I-285@ CR 4519/Atlanta Road

GDOT Project Number: STP00-0222-01(001), P.I. No. 752300

Value Engineering Study Report

June 2009

ACT. NO.
H2-6
SH 3 of 11

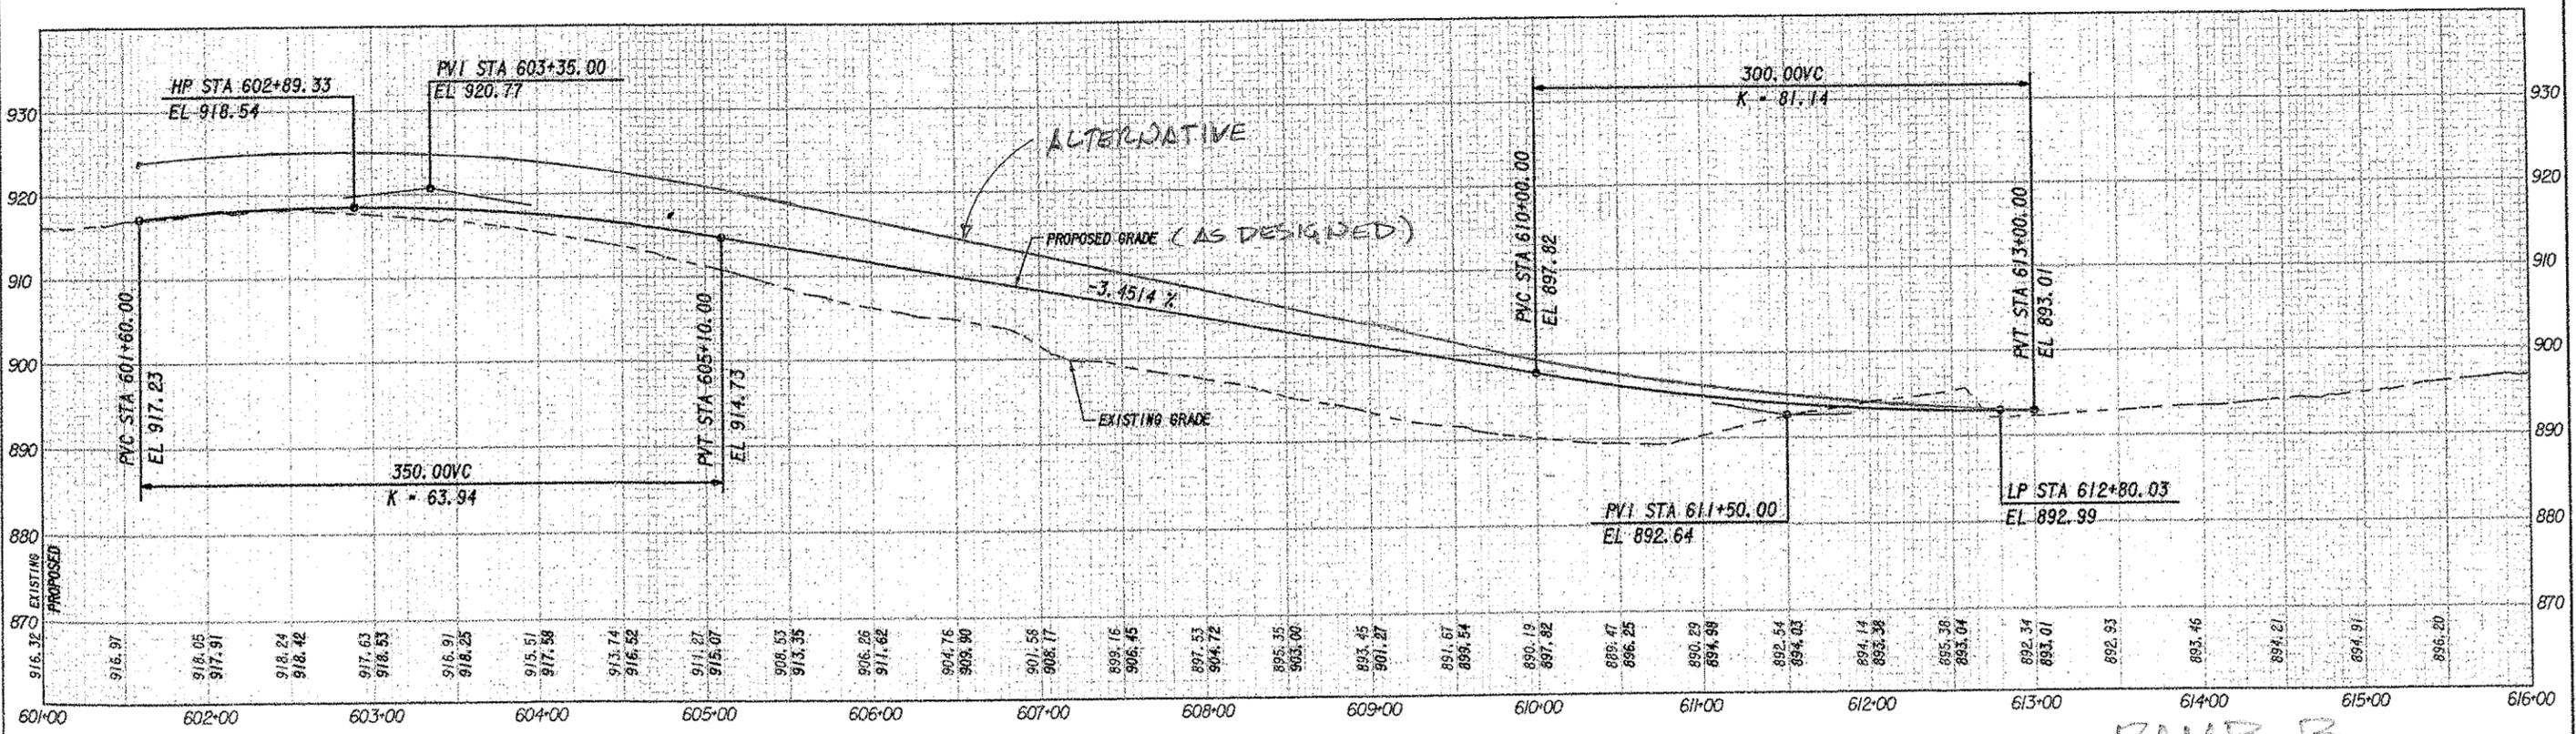
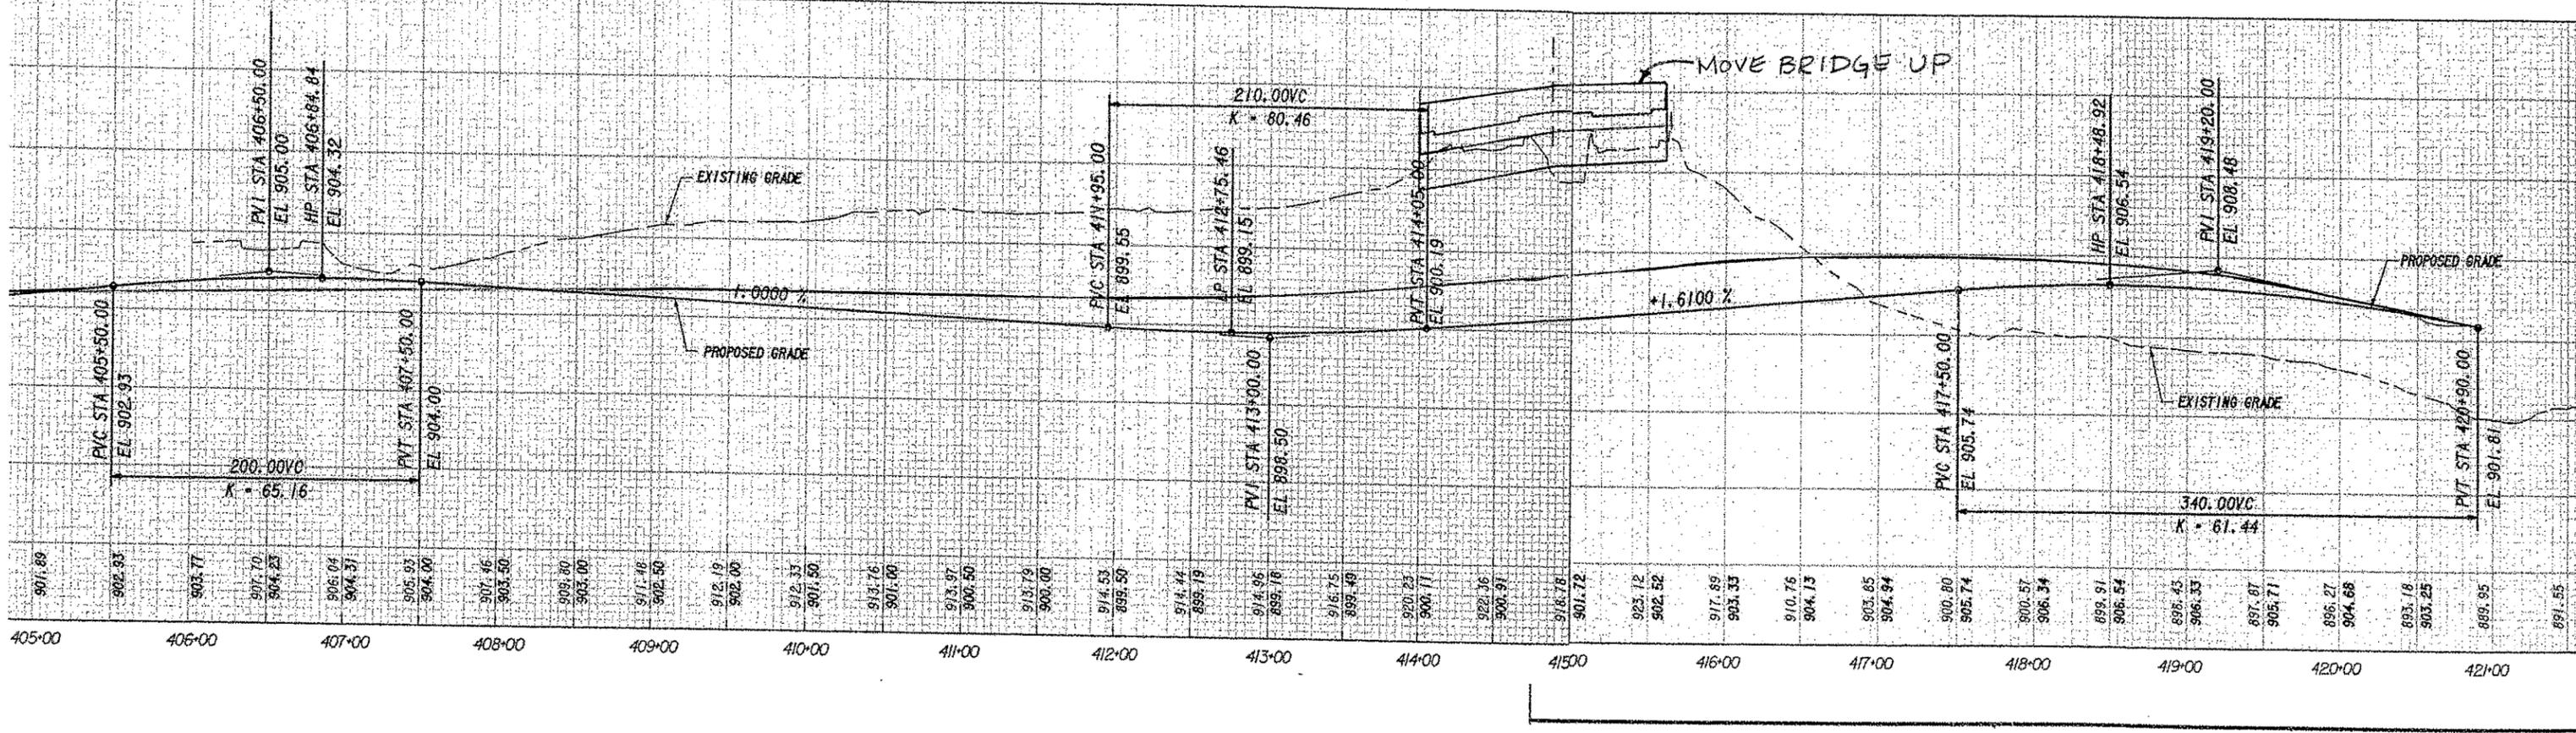
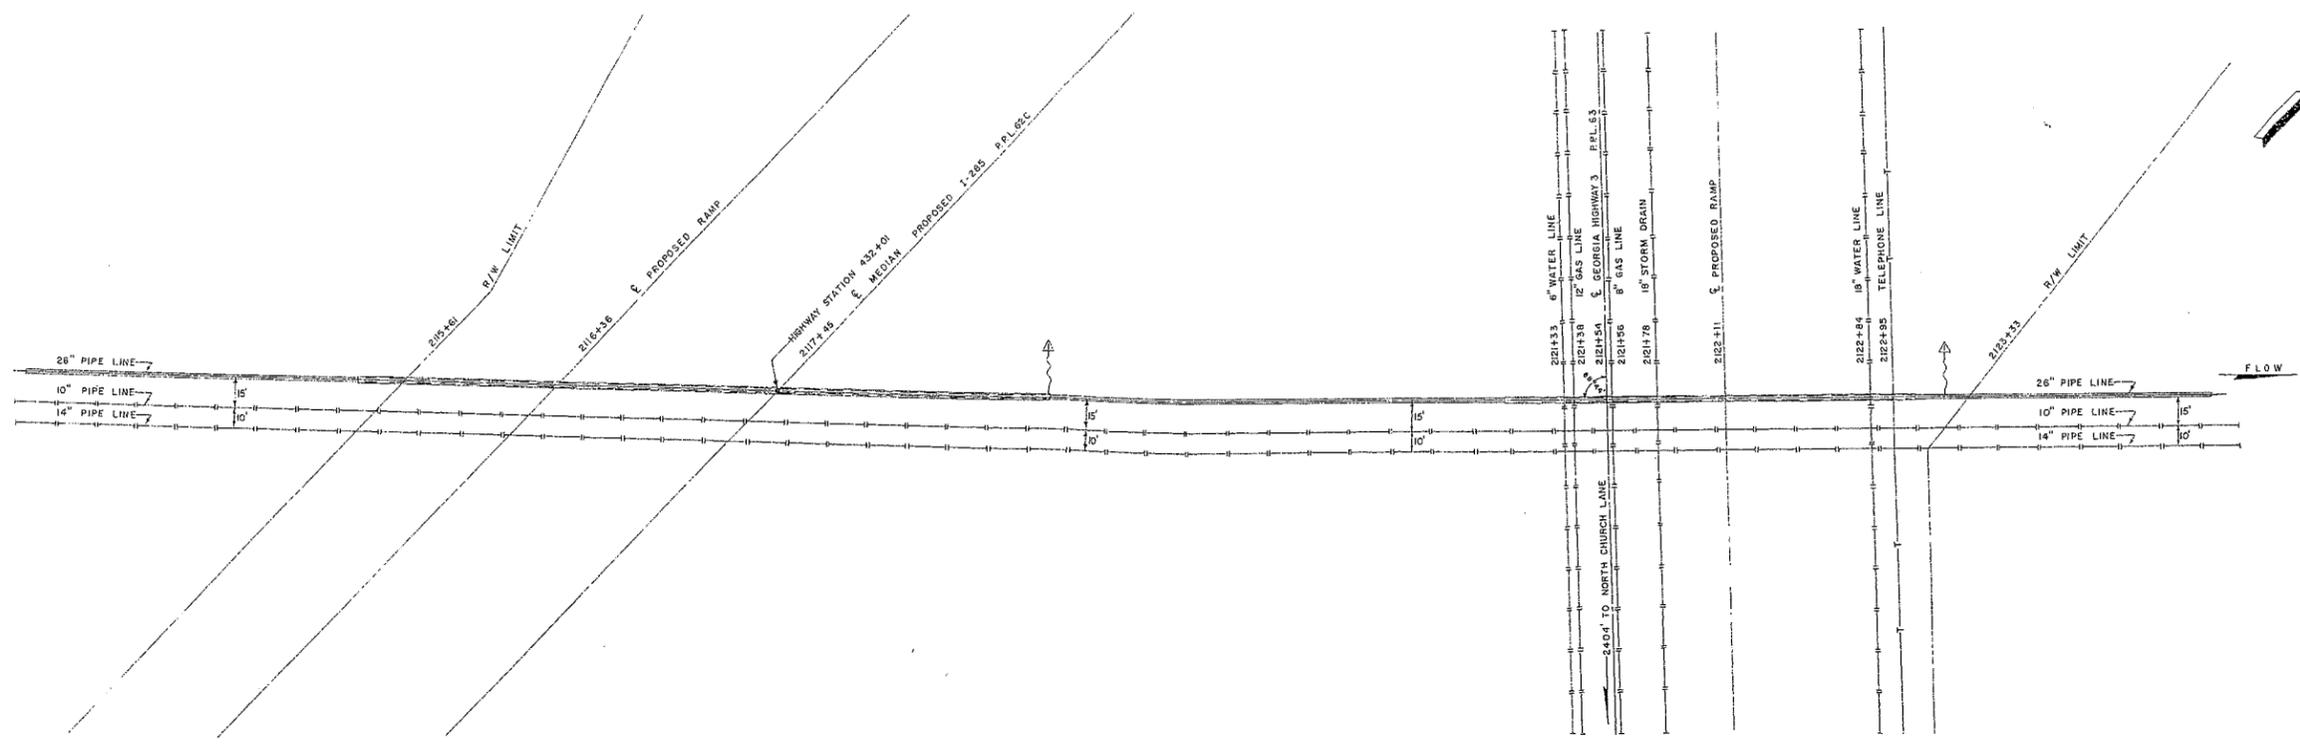
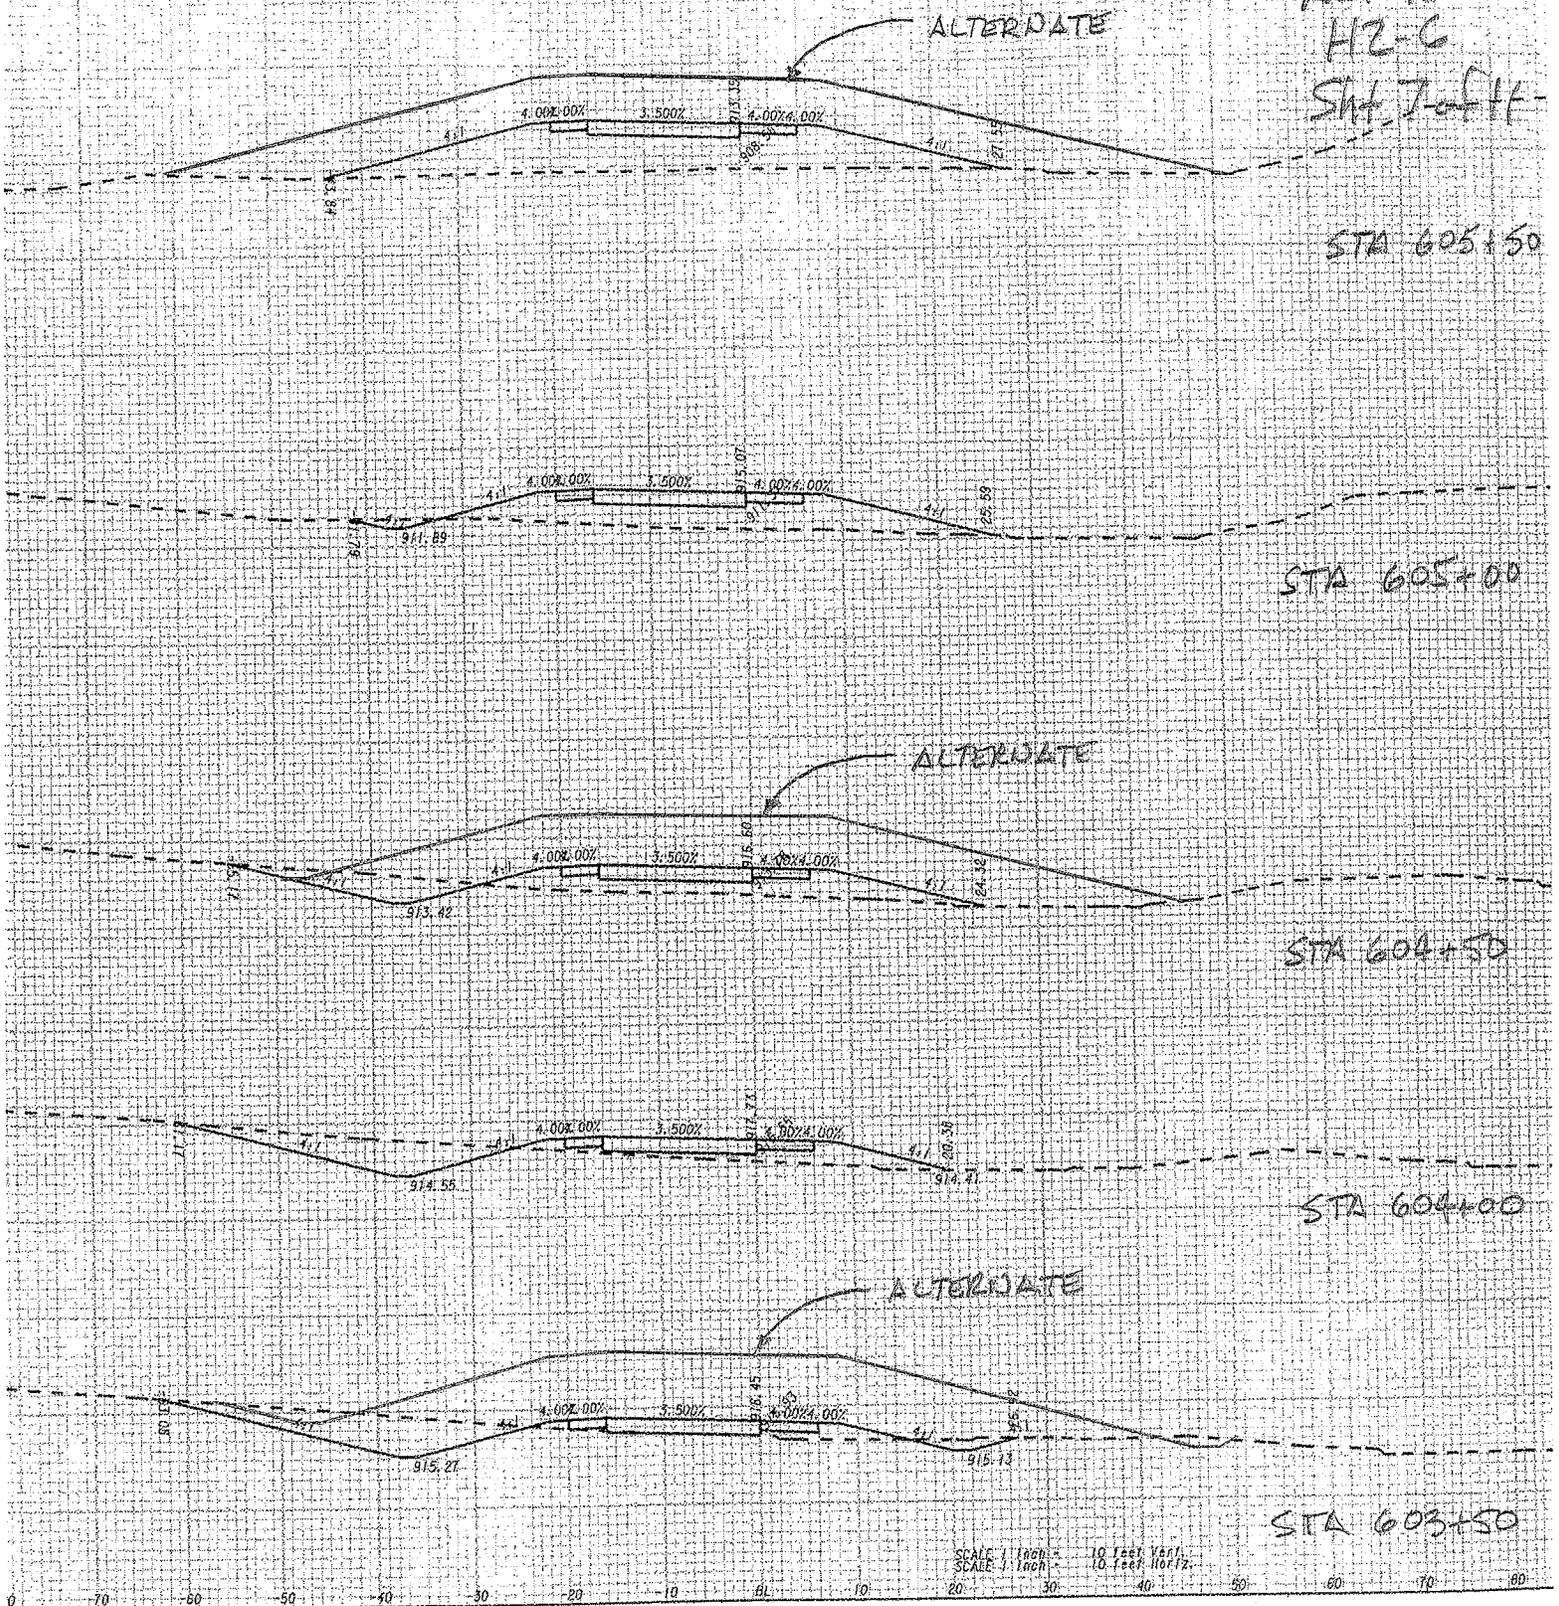
Raise the Atlanta Road Bridge profile on the east side sufficiently so that the new northbound I-285 CD lanes will be above the existing pipeline. Build the new CD lanes with a bifurcated median barrier so that the west side of the new lanes is higher than the east side of the existing lanes and high enough to provide adequate cover over the existing Colonial Pipeline. Raise the profiles of Ramps B and D to match the profile of Atlanta Road and the profile of Ramp D to also provide sufficient cover over the Colonial Pipeline.

This alternative will necessitate staging the Atlanta Road construction and making accommodations for raising the road east of the bridge. Included in this is the addition of sheet piling between the existing eastbound and westbound lanes of Atlanta Road. It is believed that the amount of extra fill material for Ramp B will be offset by the reduction in cut material for Ramp D.
